October 18, 2018

Re: 3 lot Subdivision for Nicholas Gallela (Nima Contracting) tax map: 102.4-2-32.810

The responses to MH&E comment letter from Patrick J. Hines dated 10/12/18 are as follows:

## Site Plan Proposed Catch Basin at end of existing

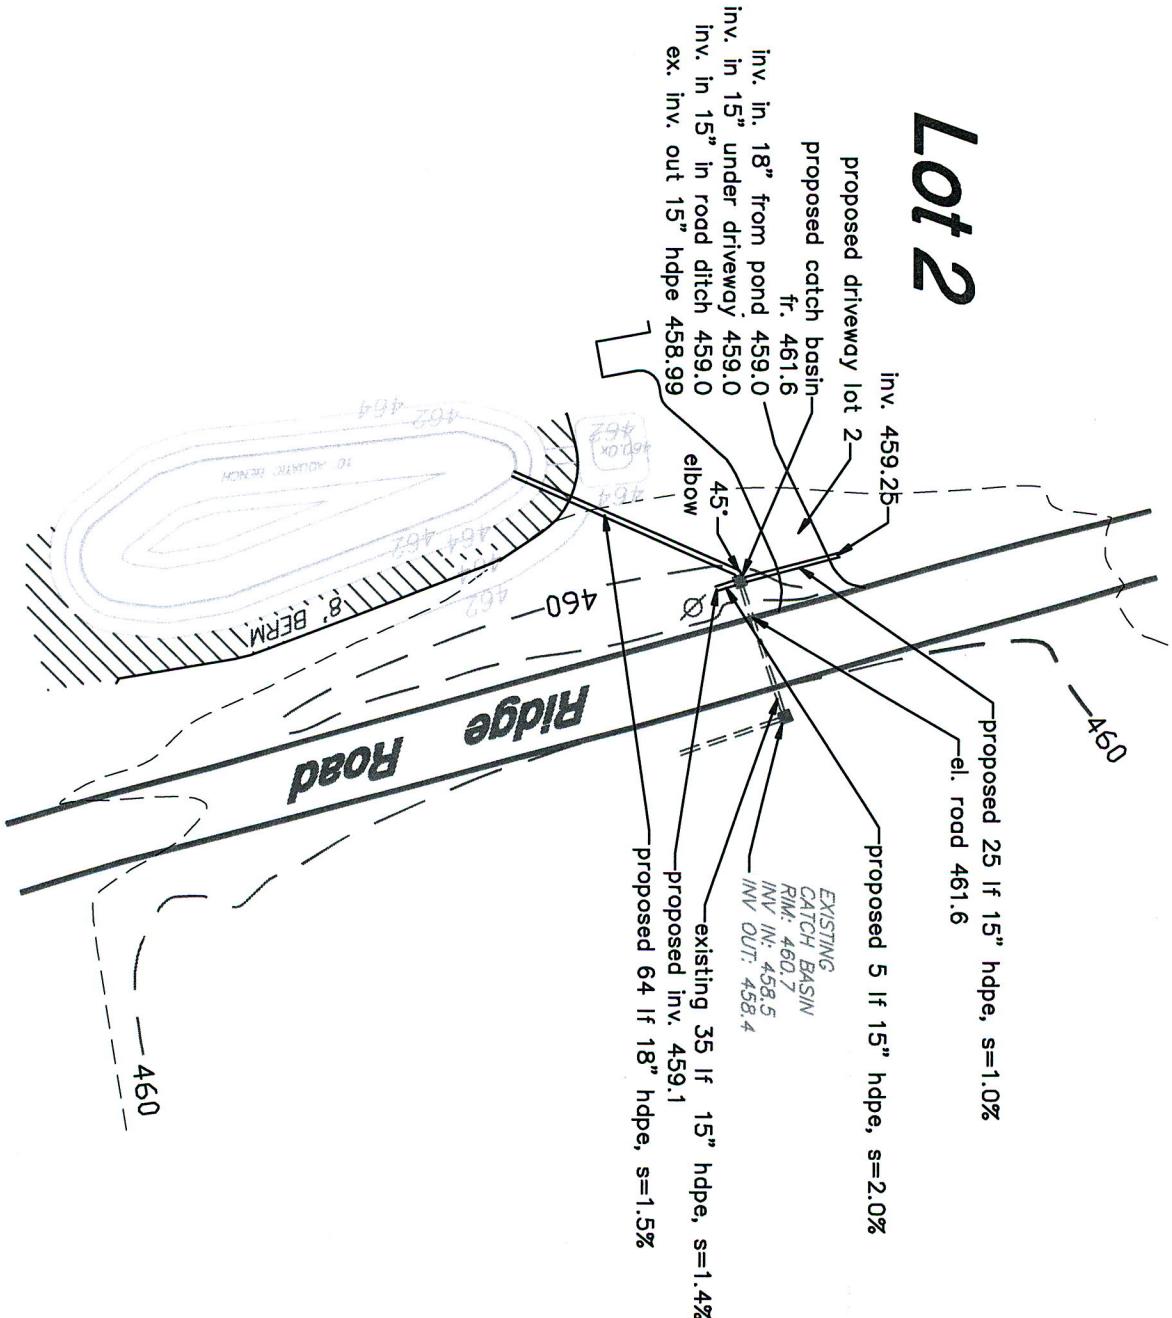
I have evaluated the possibility of a direct connection to the existing 15" hdpe culvert (formerly a 12" cmp) under Ridge Road with the following results as per my sketches in item 3 above.

b. A proposed catch basin at the end of the existing 15" hdpe under Ridge Road would have to be placed over the existing 15" hdpe. There would then likely be a configuration as per my sketch maps. From the north a new 15" hdpe would be placed under the driveway for Lot 2 and connect to the catch basin. From the south a short stub of 15" hdpe would be placed in the existing roadside ditch. From the detention pond the revised 18" hdpe would run through a 45° elbow and into the catch basin.

c. The elevation of the frame and grate of the proposed catch basin would be of concern. If the basin were constructed per the Woodard's model CB-30x30 (which I have shown) then the frame elevation would be the same height as the edge of pavement of Ridge Road, and no stormwater would enter the top of the basin. If the basin were modified such that the 6" of concrete above each of the 4 knockouts were removed then this would allow for the frame and grate to be 6" lower than the edge of the road. Even so the grate would not take in much stormwater, but it would be less of an issue when plowing snow on Ridge Road. The existing catch basin on the east side of Ridge Road is approximately 8" below the edge of pavement of Ridge Road and does not take in much stormwater.

Note: The Preliminary Plan attached herewith shows the original design for the 24" hdpe at 0.49% out of the detention pond as per the original subdivision in 2010. I can revise this to the above configuration upon review from Mr. Hines.
